SERVICE INFORMATION NO. SI-D4-131

GARMIN Service Alert No. 0824 Revision C
ATA-Code: 34-00

NO.: 0824 Rev C

TO: All G1000/G900X/G950 Owners and Operators
DATE: 20 November 2009
SUBJECT: GDU 104X CRS/BARO Knob Interference
REVISION C: Added note regarding Service Bulletin 0823 in Affected Products section

Figure 2

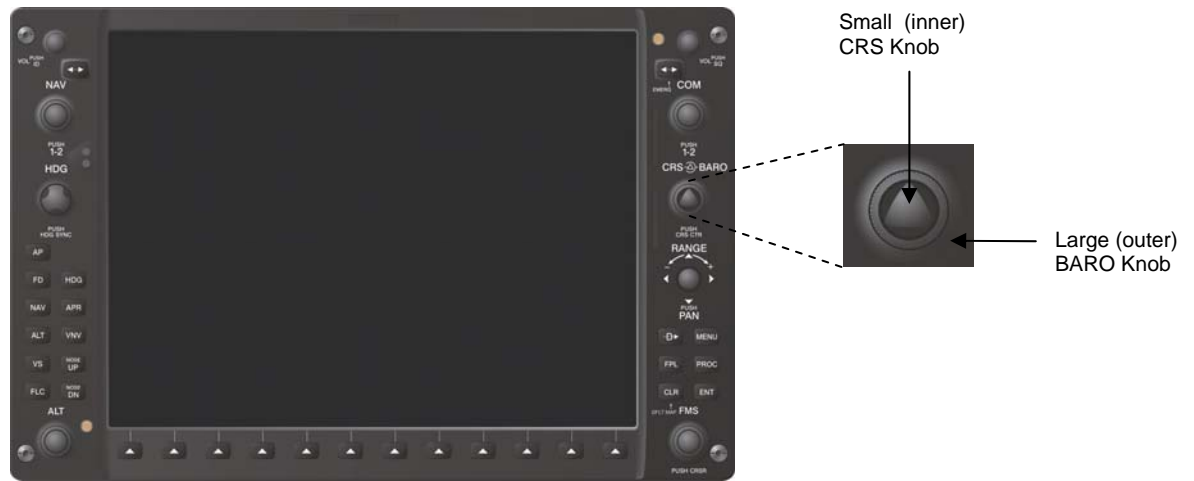
Garmin has identified an issue, whereby the large (outer) BARO knob and the small (inner) CRS knob may interfere with each other.

1. Apply power to the G1000/G900X/G950.
2. Press the CDI softkey on the Primary Flight Display(s) (PFD) to enter VOR mode on the HSI.
3. Rotate the large (outer) BARO knob (refer to Figure 2) a minimum of three complete revolutions in each direction while monitoring the Horizontal Situation Indicator/Digital Course Indicator (refer to Figure 3) on the PFD. If a change in the Horizontal Situation Indicator/Digital Course Indicator is produced while turning the BARO knob contact your local Garmin Service Center or OEM Dealer to replace the knobs.

4. Rotate the small (inner) CRS knob (refer to Figure 2) a minimum of three complete revolutions in each direction while monitoring the Barometric Altimeter Setting (refer to Figure 3) on the PFD. If a change in the Barometric Altimeter Setting is produced while turning the CRS knob contact your local Garmin Service Center or OEM Dealer to replace the knobs.
5. Repeat Steps 3 and 4 for each affected GDU.
